EL PASO COUNTY FILE NO. PCD # SF-20-014

CLAREMONT BUSINESS PARK 2 FILING NO. 1

STREET IMPROVEMENT PLANS

CDS_v3_redlines.pdf Markup Summary

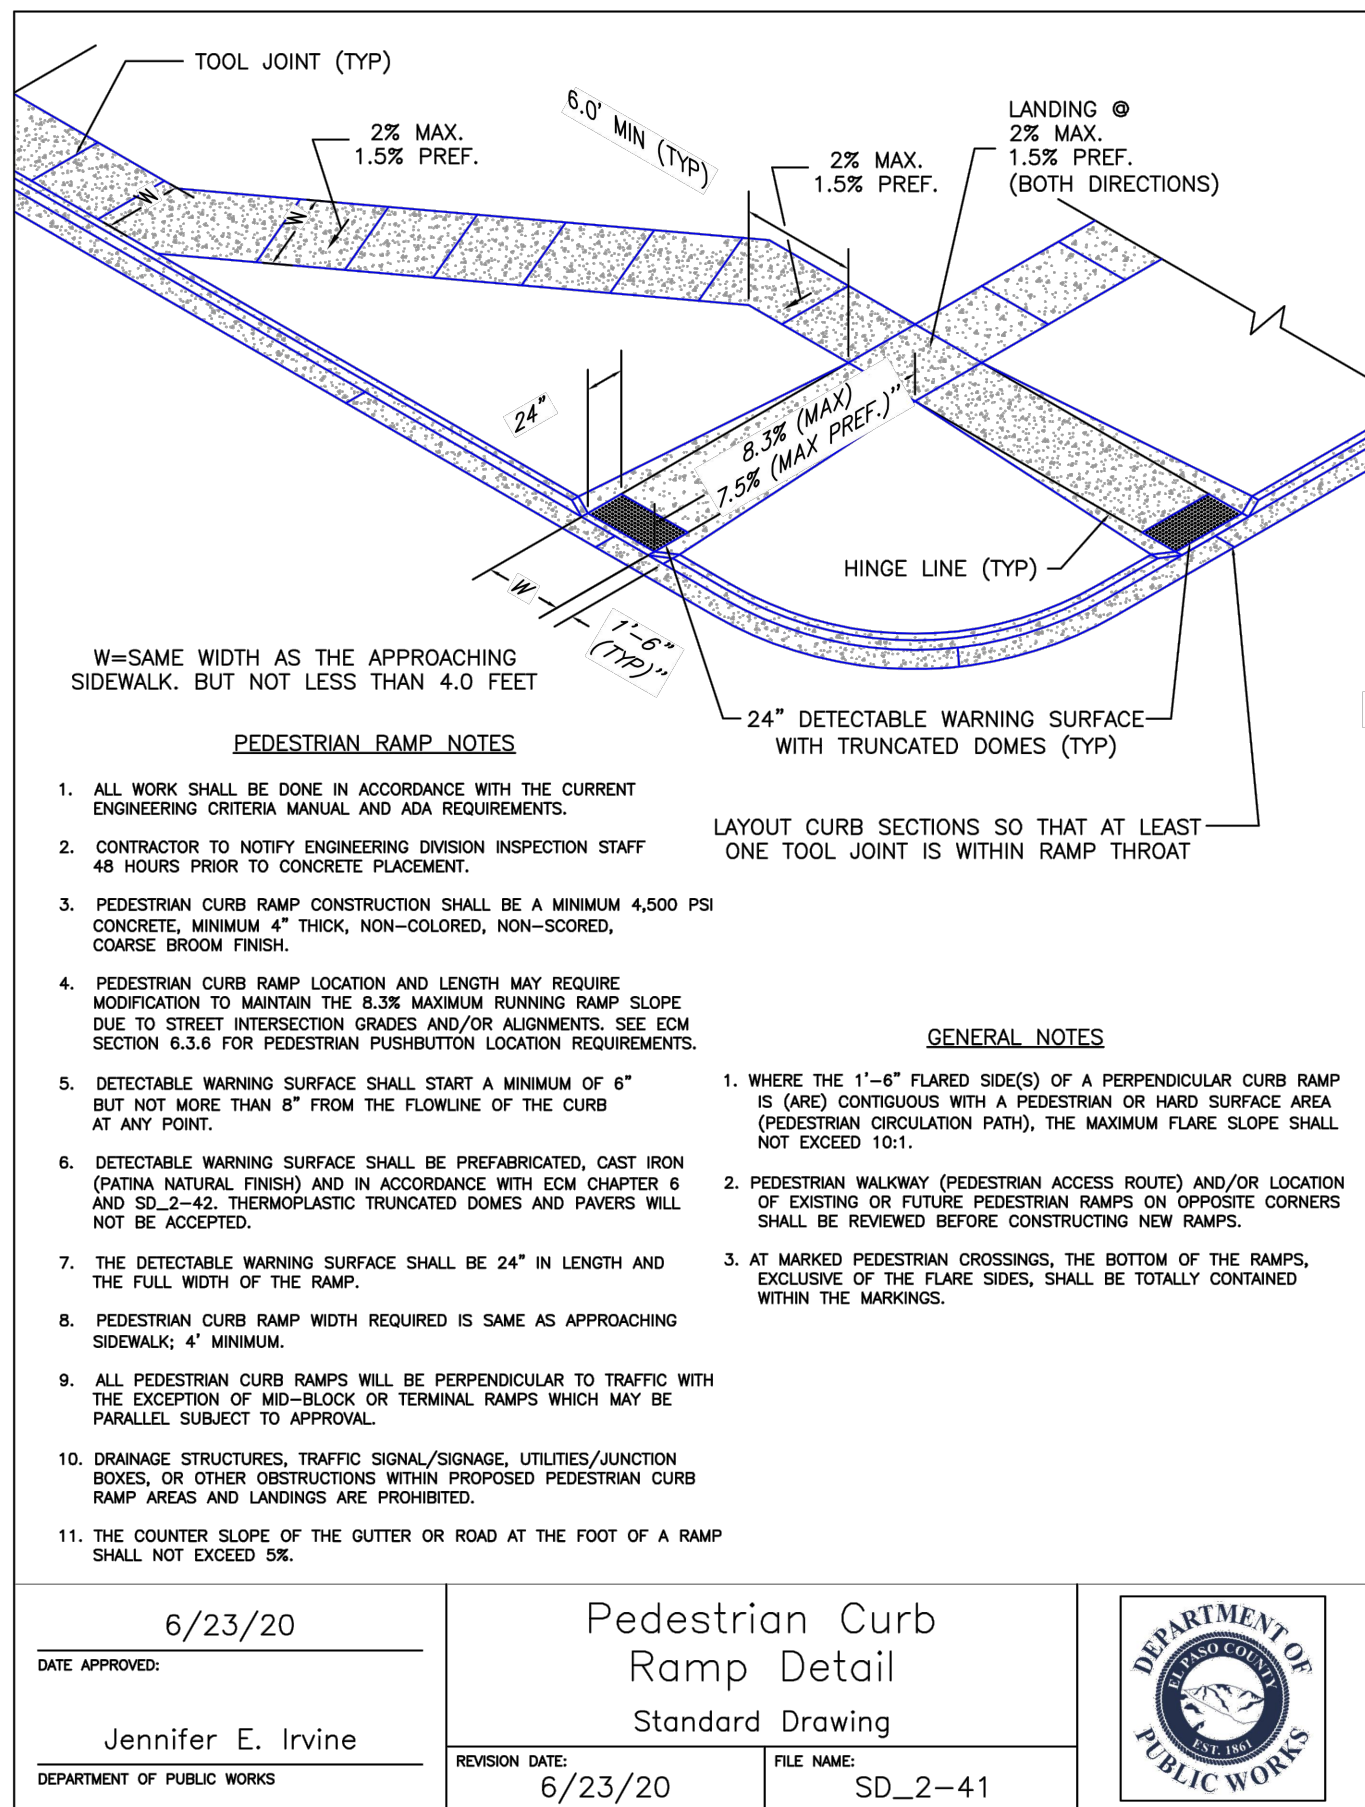
Fix text overlap
